From: Michael Stephenson <mstephenson@cameron-cole.com>
Sent: Wednesday, July 23, 2014 5:08 PM
To: Jump, Christine; SMITH, MARTIN L
Cc: Akhter Hossain
Subject: RE: Reporting Limits and Detection Limits table
Attachments: 1808-Soil-Metals.pdf

From: Jump, Christine [mailto:Jump.Chris@epa.gov]
Sent: Monday, July 07, 2014 1:12 PM
To: Michael Stephenson; SMITH, MARTIN L
Cc: Akhter Hossain
Subject: Reporting Limits and Detection Limits table

SOIL METALS SAMPLING LOCATIONS and IAO EXCEEDANCES CLEAN HARBORS KANSAS, LLC		
SCALE:	AS SHOWN	PROJECT: 1808

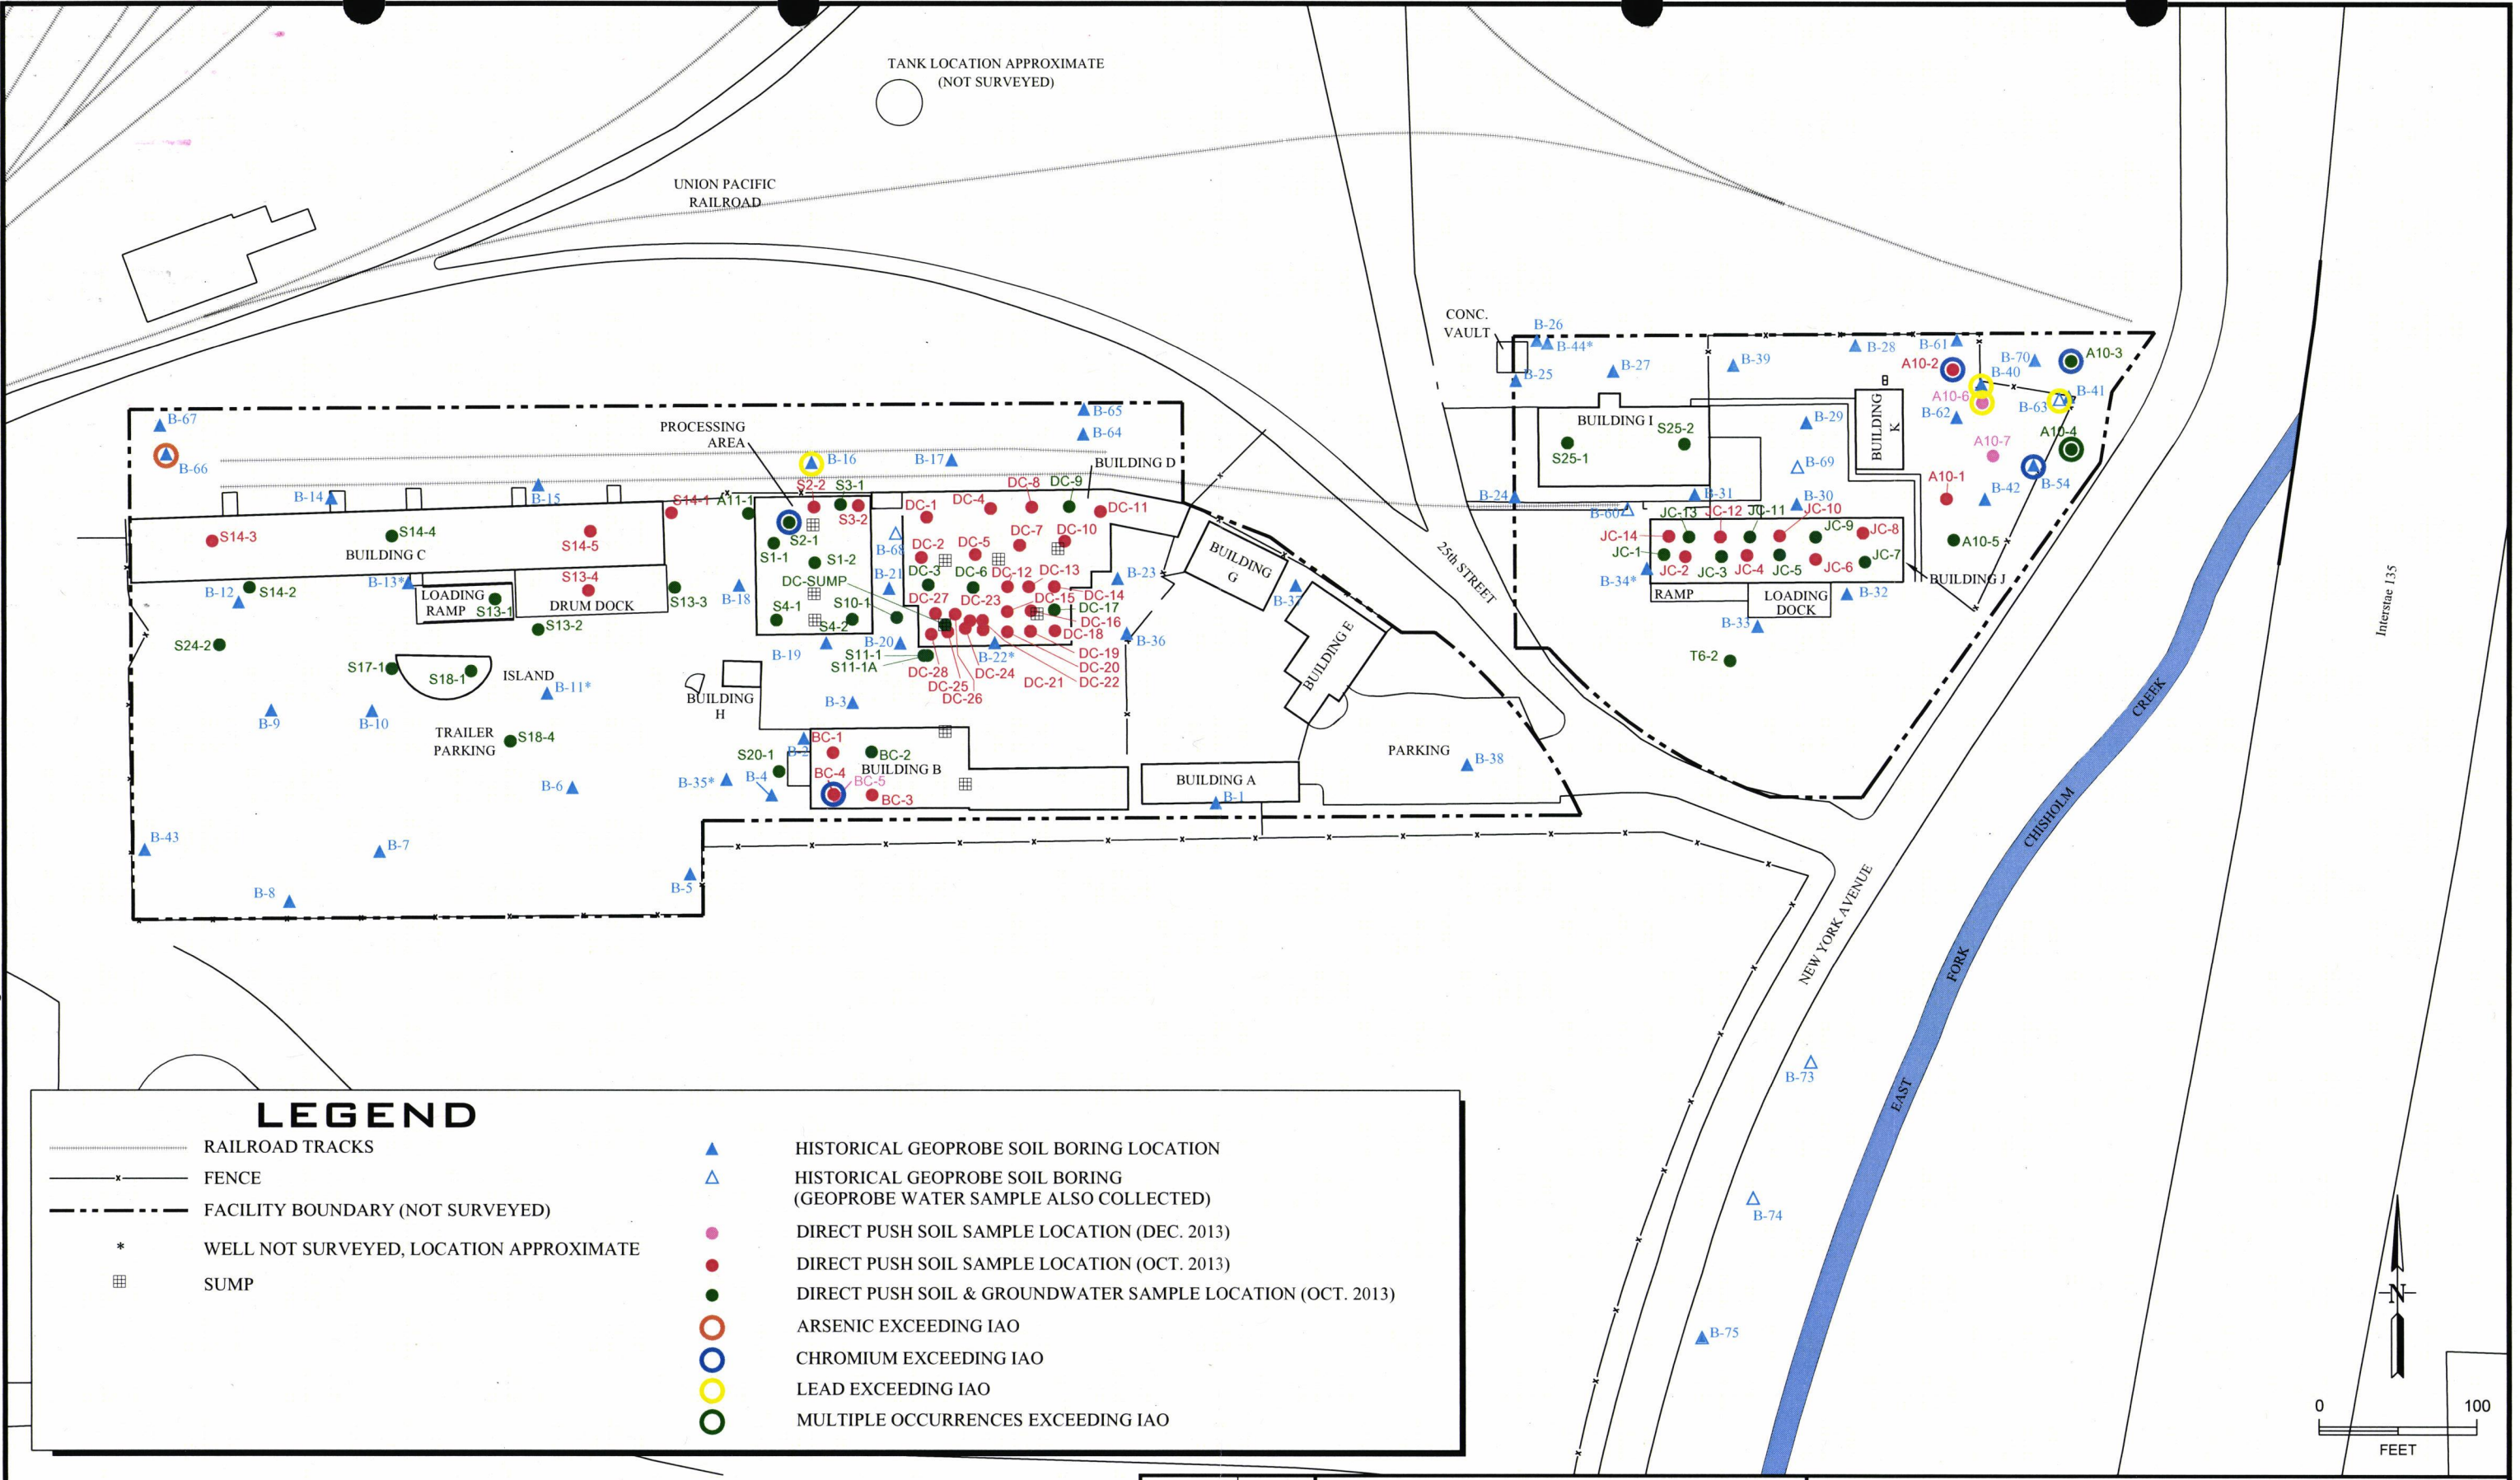
- 4) The table states, "Other compounds to be analyzed at a frequency of 10% of the total VOC analyses, where specified." Since elevated metals have been detected in several locations across the site, EPA will require that metals be analyzed at the same frequency as VOCs.

There are only three metals results that exceed IAOs that are not within the proposed limits of our excavation (B-67, B-16 and BC-4). There have been numerous samples collected for metals across the site that document that they are not present at concentrations exceeding IAOs across most of the Site.

For this reason, I propose the following. We will collect confirmation samples for metals at the same frequency as the VOC confirmation samples in the following areas.

1. Northeastern corner (Lead and chromium)
2. Processing Area (chromium)

Confirmation samples for metals in all other areas will be collected at a rate of 10% of the VOC samples.

Any residual metals concentrations, from either the existing three samples not captured by the ongoing IRM, and any confirmation samples that are not further excavated during the IRM will be addressed in the CMS/risk assessment.
